REMARKS

In the Office Action dated January 11, 2006, the Examiner stated that the title of the invention is not descriptive and a new title is required that is clearly indicative of the invention to which the claims are directed.

UTILITY PATENT APPLICATION TRANSMITTAL <i>Only for new nonprovisional applications under 37 CFR 1.53(b)</i>		Attorney Docket No. 16569	
APPLICATION ELEMENTS See MPEP chapter 600 concerning utility patent application contents		First Inventor or Application Identifier Miroslav Kostka	
		Title Control Device and Control Method for an Elevator Installation with Multiple Cars	
		Express Mail Label No. EL 975498178 US	
		MAIL STOP PATENT APPLICATION Commissioner for Patents ADDRESS TO: P. O. Box 1450 Alexandria, VA 22313-1450

FIG. 1

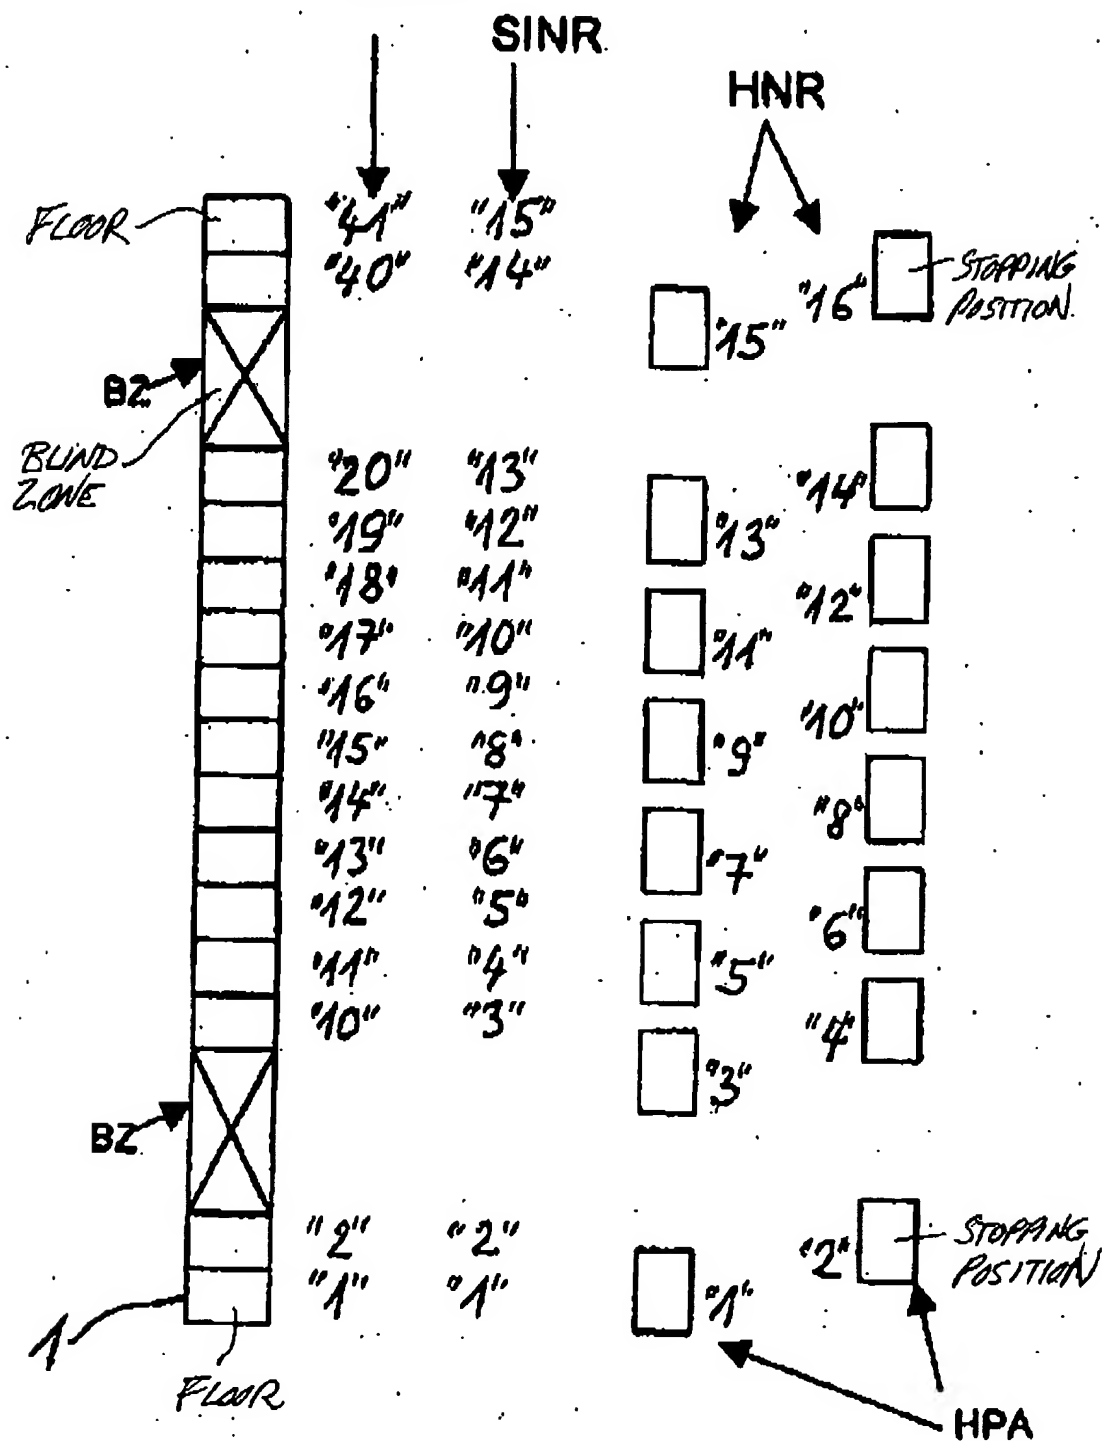
The Examiner objected to the drawings are objected because the blank rectangular boxes and/or merely numbered boxes of figures 1-3 must be labeled. The Examiner stated that Fig. 2A should be designated by a legend such as --Prior Art-- because only that which is old is illustrated.

In response to the Examiner's objections to the drawings, attached are three sheets of drawings identified as "Annotated Sheet Showing Proposed Changes" for consideration by the

Examiner. The blank rectangular boxes are labeled and the "Prior Art" legend is added to Fig. 2. Upon approval by the Examiner, Applicant will file replacement sheets.
